Access Compliance Report

Public Rights-of-Way

Intersection ID: 17609	Main Street: E_WOODLAWN_RD	Cross Street: STERLING_DR	Location: NW
ADA ID: E393662E69CA	Ramp Type: BlendTrans2	Initial Pass/Fail: Pass	Overall Compliance: No
		Severity Score: 7.5

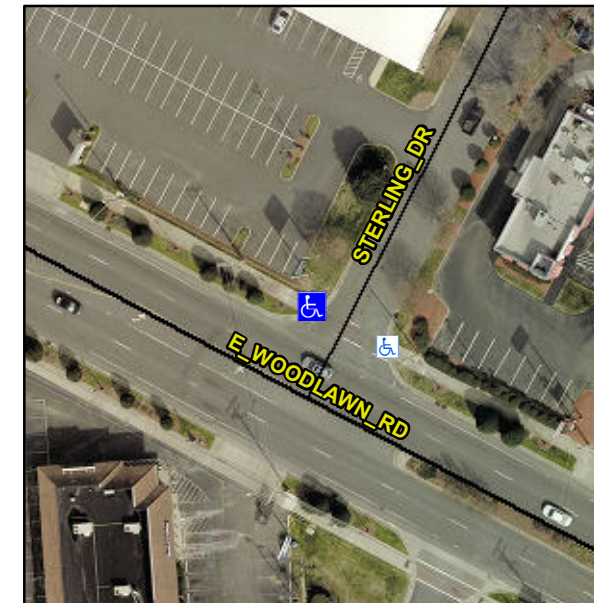
R305.1.4, R304.5.4, R304.5.3

Compliance	Description	Data	Compliance	Description	Data
N/A	Ramp Length (in)	55.0	Yes	BlendTrans Slope (%)	3.3
Yes	Ramp Width (in)	48.0	Yes	BlendTrans XSlope (%)	1.5
N/A	Flare Type LT	None	N/A	Flare Type RT	None
N/A	Flare Slope LT (%)	N/A	N/A	Flare Slope RT (%)	N/A
N/A	Flare Traversable LT?	N/A	N/A	Flare Traversable RT?	N/A
N/A	Landing Length (in)	N/A	Yes	DWS Provided?	Yes
N/A	Landing Width (in)	N/A	Yes	DWS Contrast?	Yes
N/A	Landing Slope (%)	N/A	Yes	DWS Length (in)	24.5
N/A	Landing X Slope (%)	N/A	No	DWS Full Width?	No
N/A	Landing Curb? (Y/N)	No	Yes	DWS Offset (in)	2.0
N/A	Shared Landing?	No			
Yes	Gutter Ponding?	No	No	Gutter Slope (%)	5.4
Yes	Gutter Lip Ht (in)	0.0	No	Gutter X Slope (%)	2.9
N/A	Painted X Walk1?	No	N/A	Painted X Walk2?	Yes
	X Walk 1 Direction	To SW		X Walk 2 Direction	To SE
	X Walk 1 Width (in)	N/A		X Walk 2 Width (in)	105.0
	X Walk 1 Slope (%)	4.5		X Walk 2 Slope (%)	0.9
	X Walk 1 X Slope (%)	0.9		X Walk 2 X Slope (%)	3.1

Remove & Replace Detectable Warning System. Remove & Replace Gutter.
